SANDSTONE PRECINCT

23-39 BRIDGE STREET
SYDNEY NSW, 2000

**PROPOSED PLANS - LANDS BUILDING -
LOWER GROUND, EDUCATION BUILDING -
BASEMENT 01**

FOR APPROVAL

TITLE
FAÇADE DETAILS - EDUCATION BUILDING - GLASS BAY

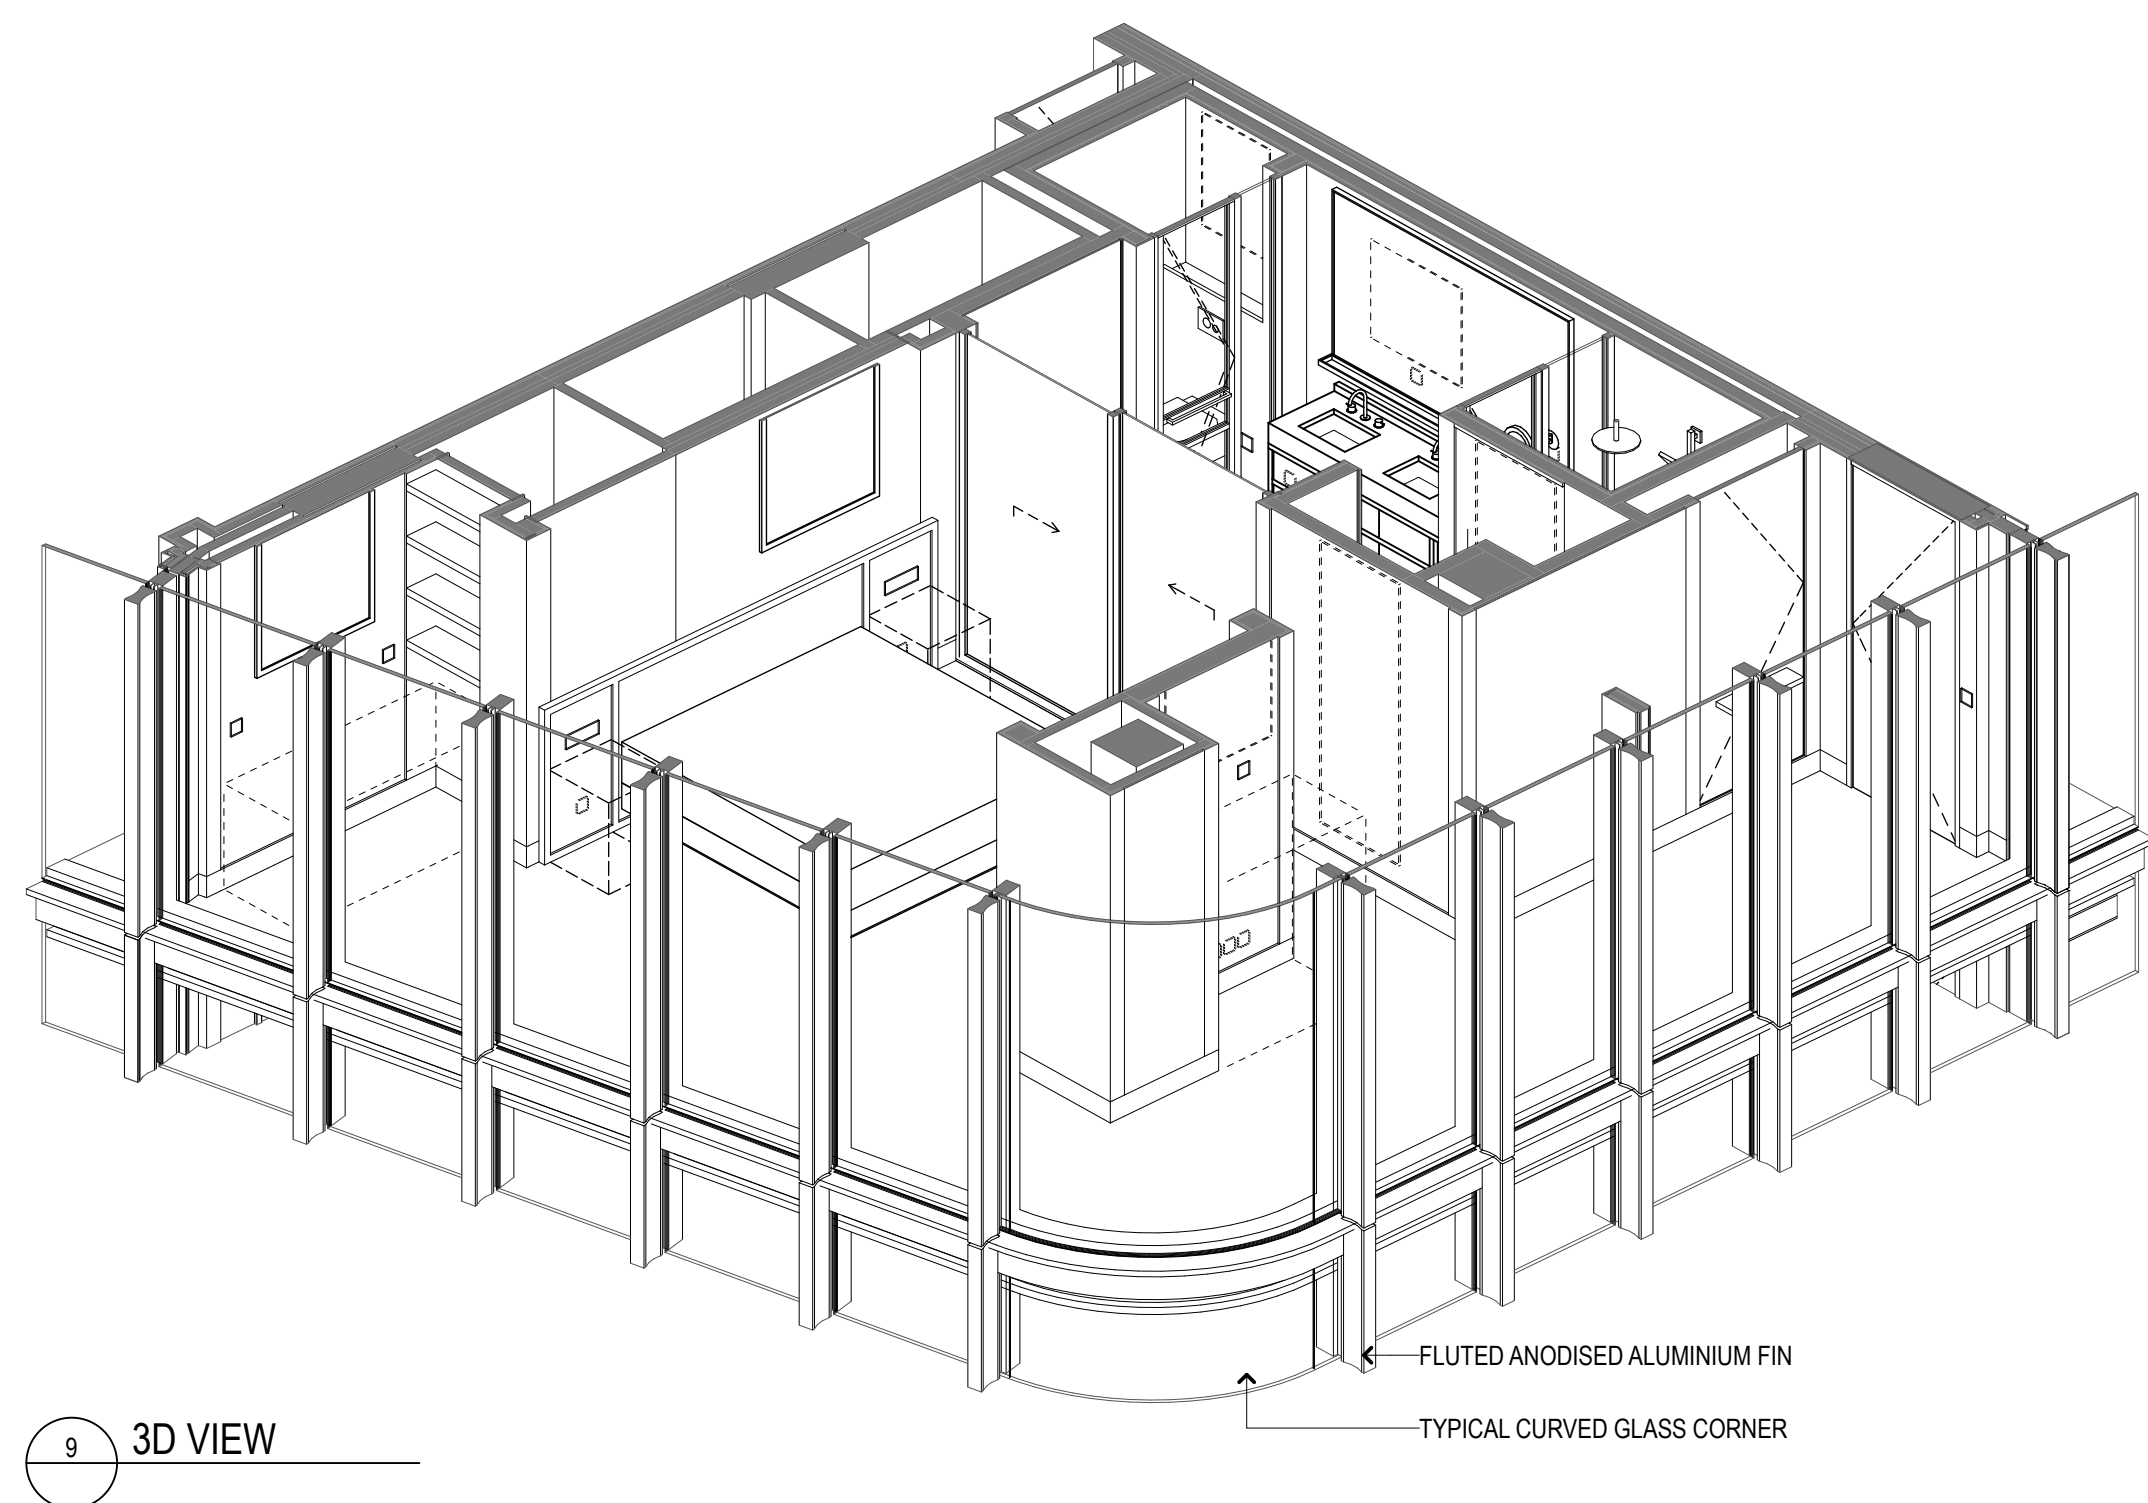
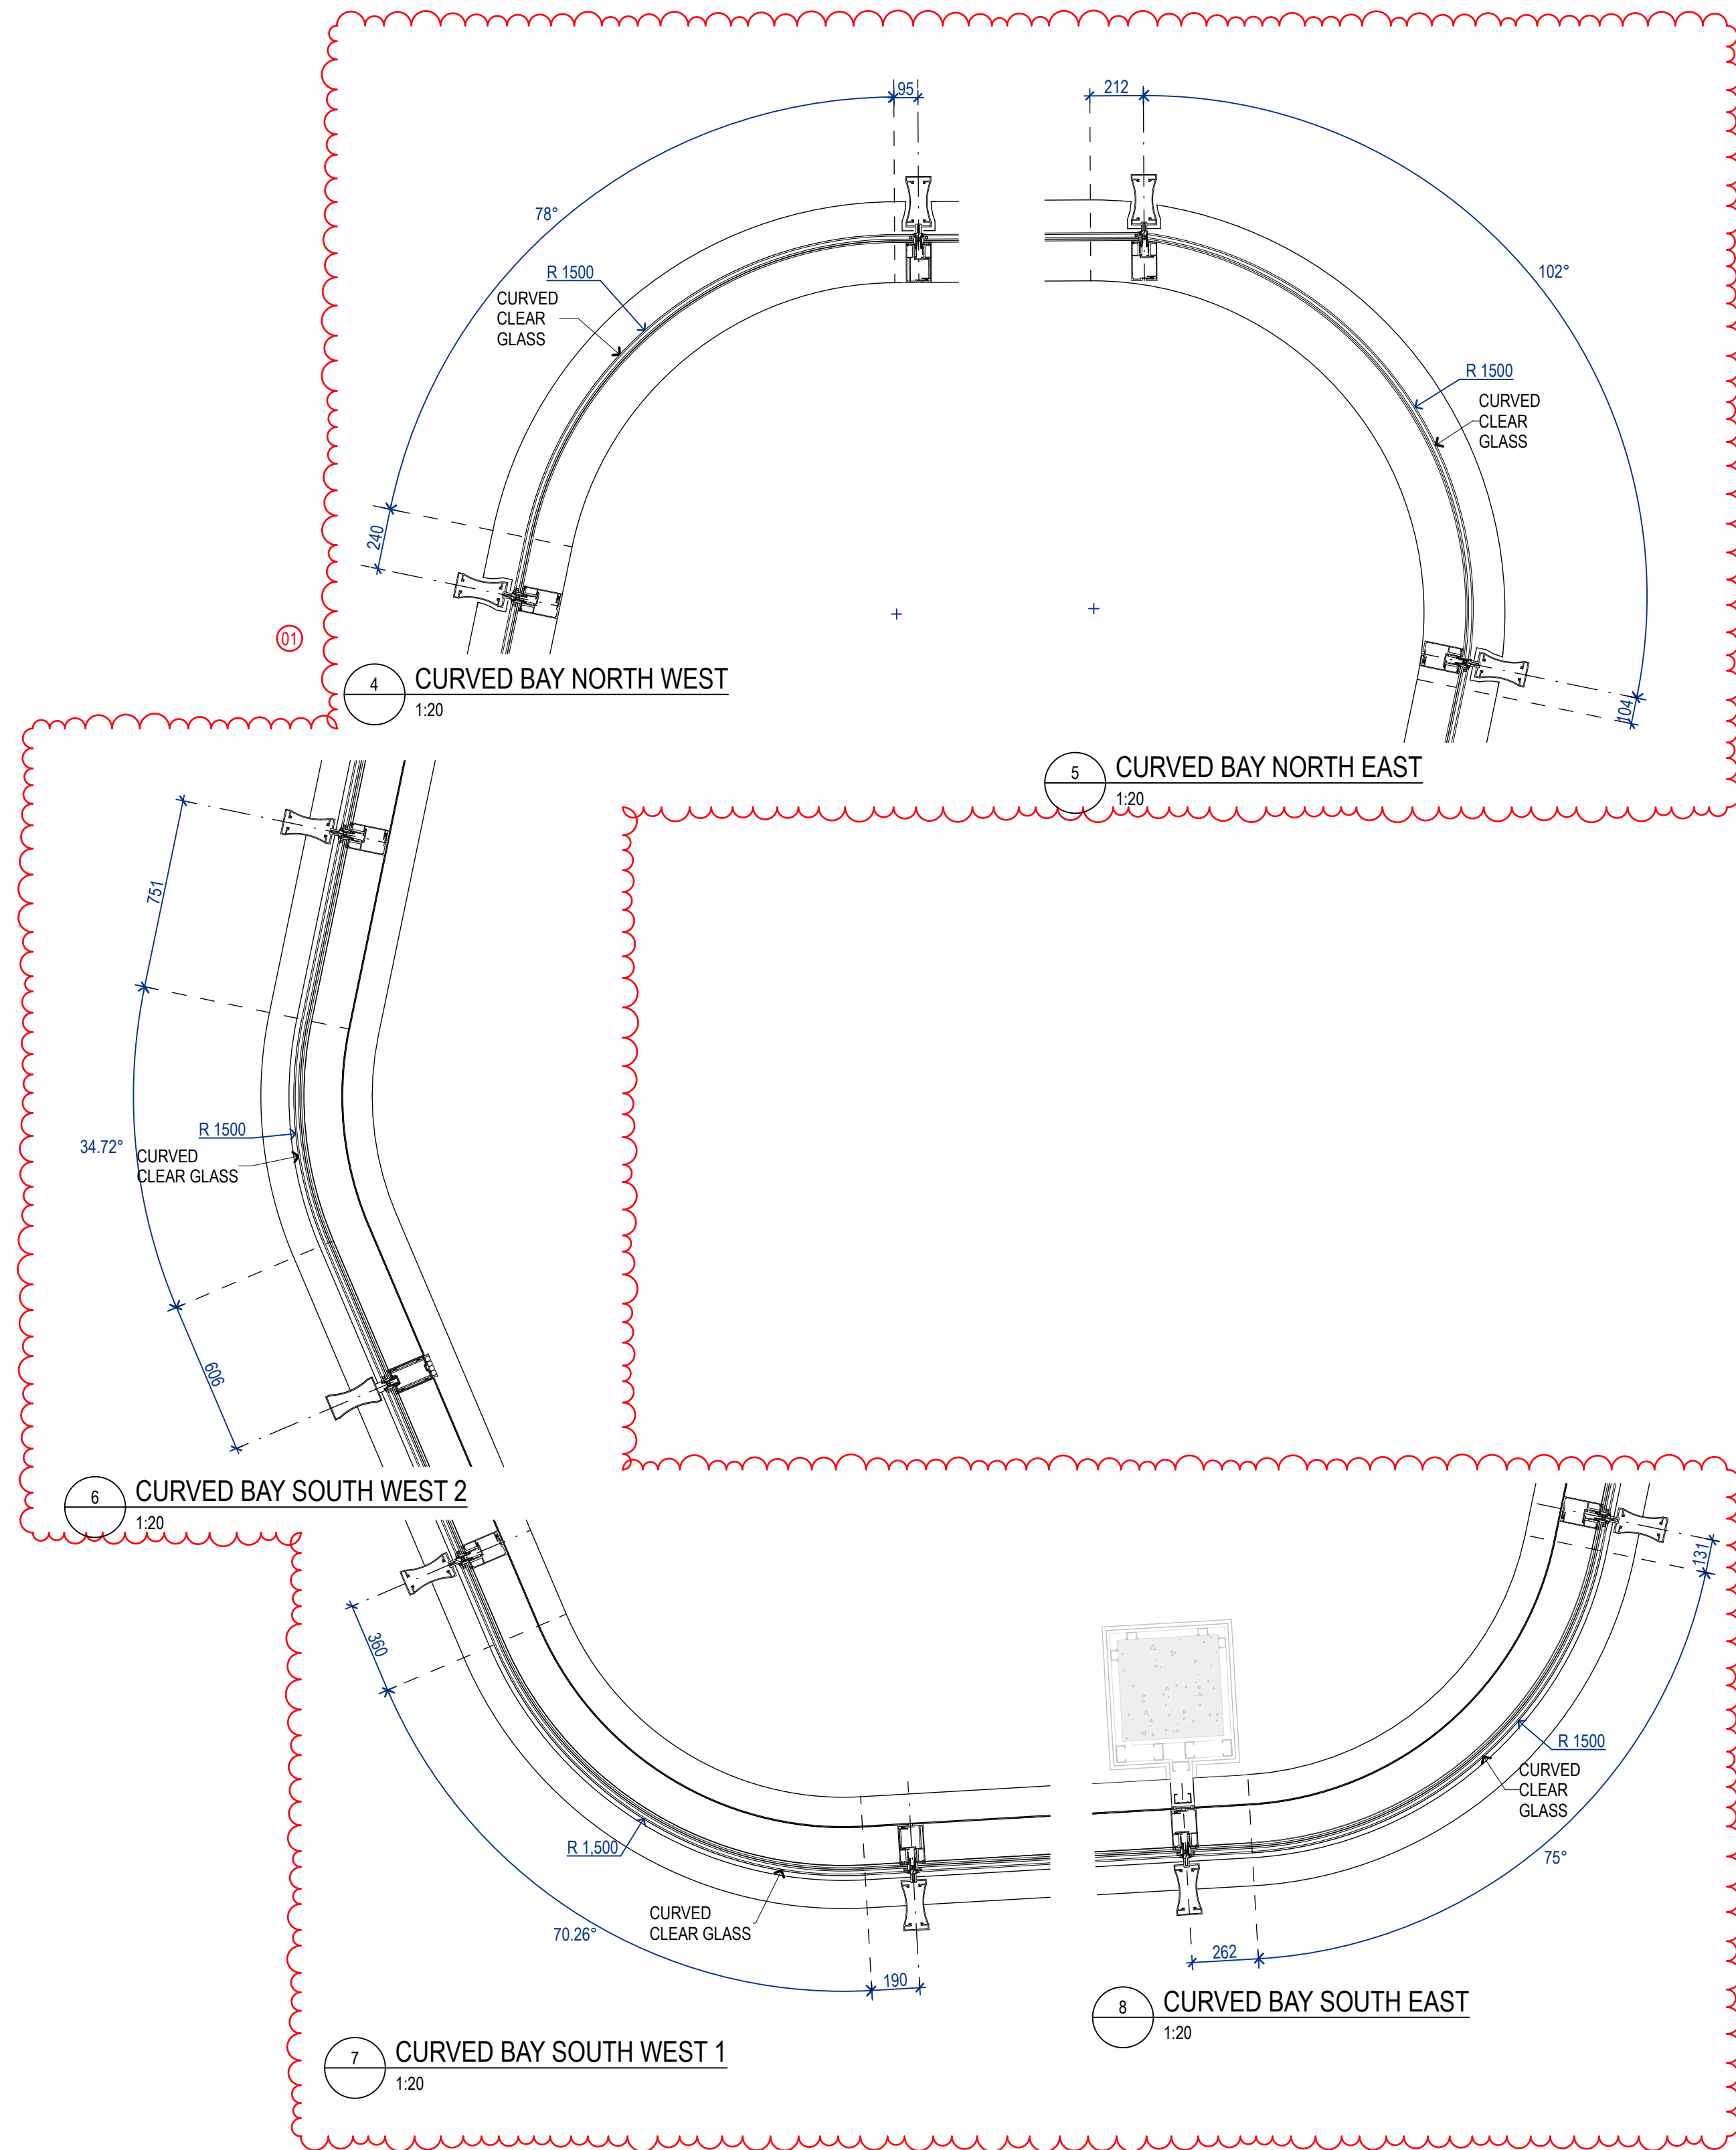
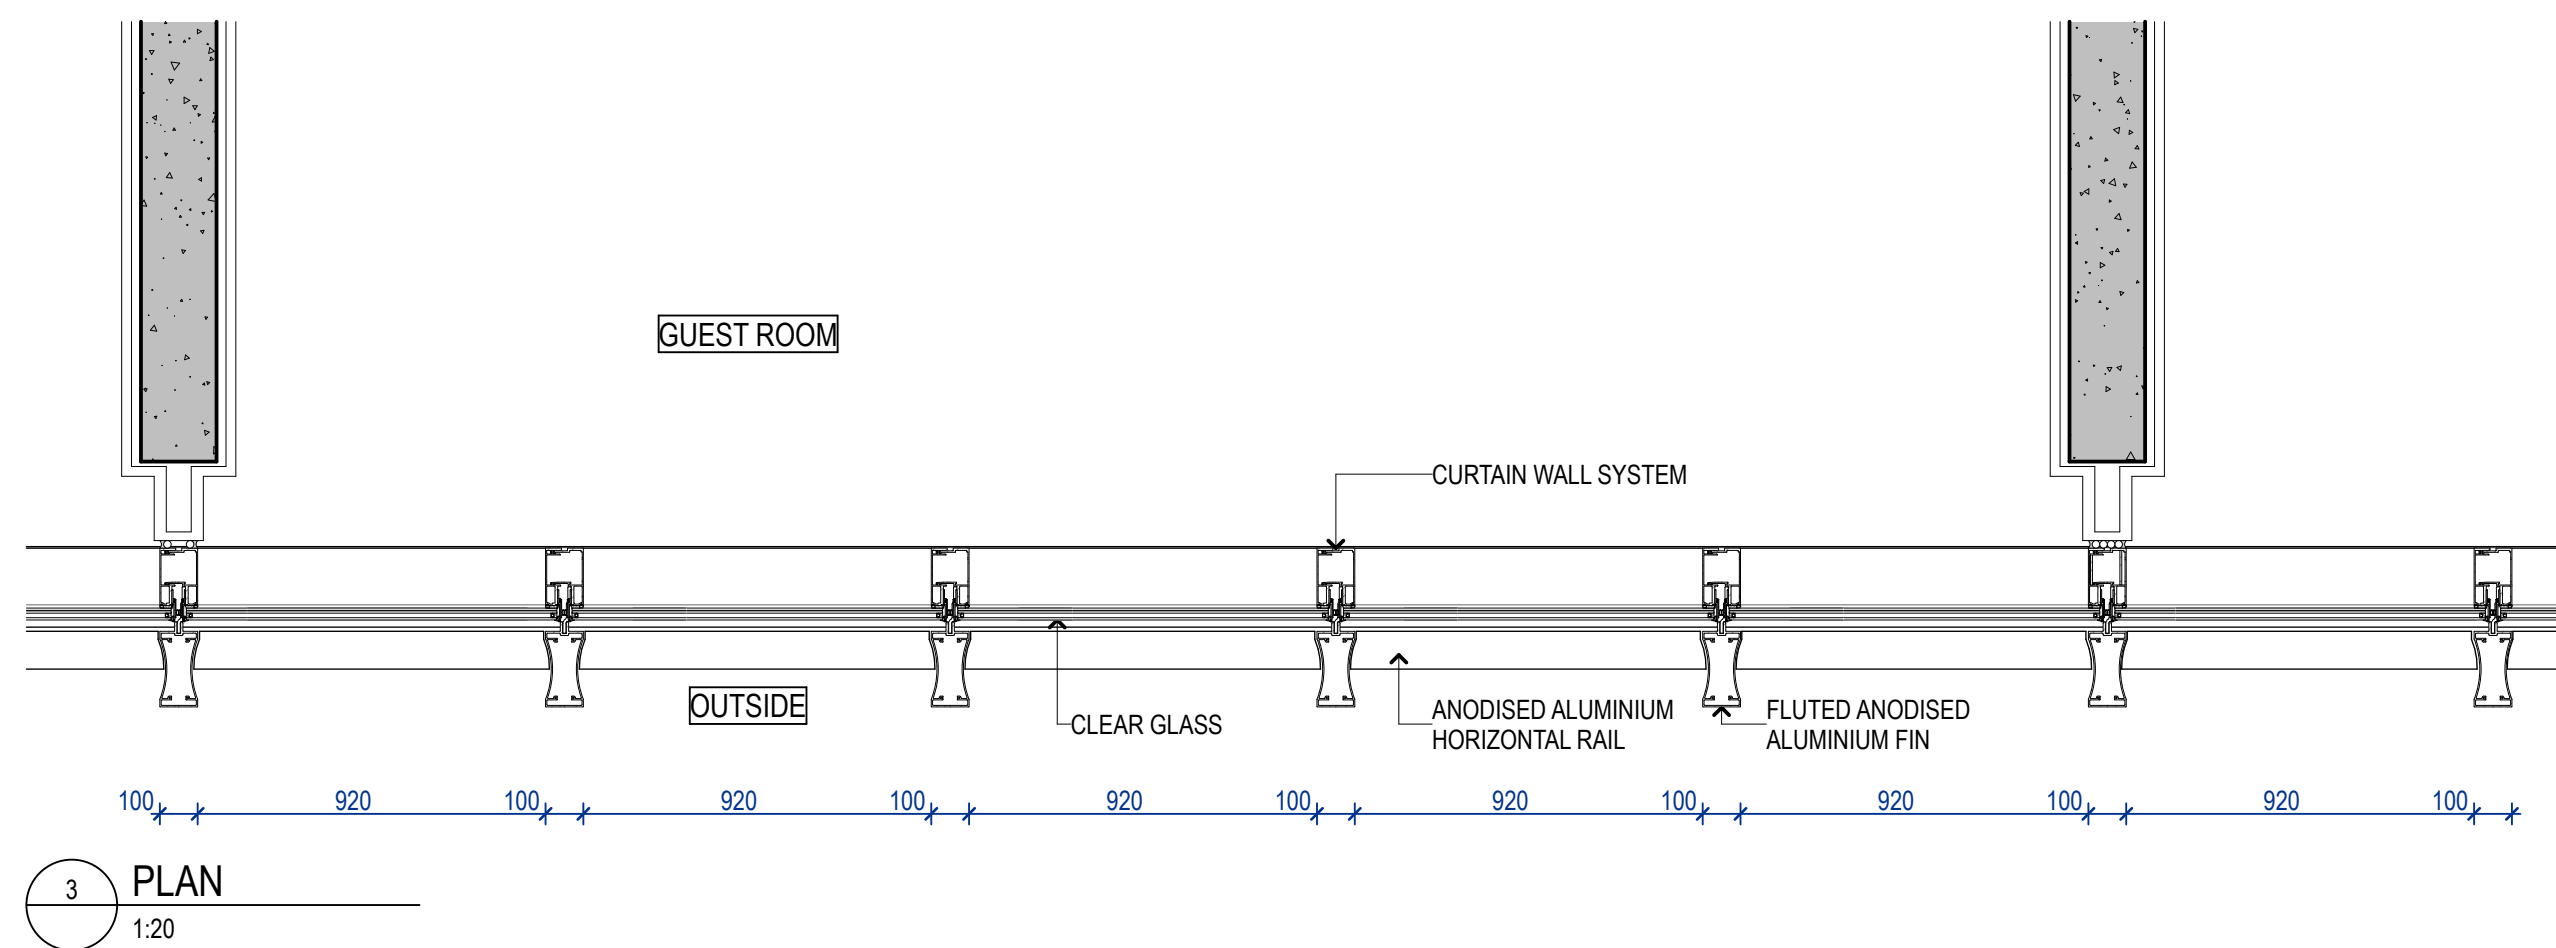
CHANGES LEGEND:
(01) CURVED GLASS CHANGED TO 1500MM RADIUS
(02) UPDATED INTERNAL BLACKOUT BLIND & SHEAR CURTAIN DETAIL
(03) ADDED BALUSTRADE
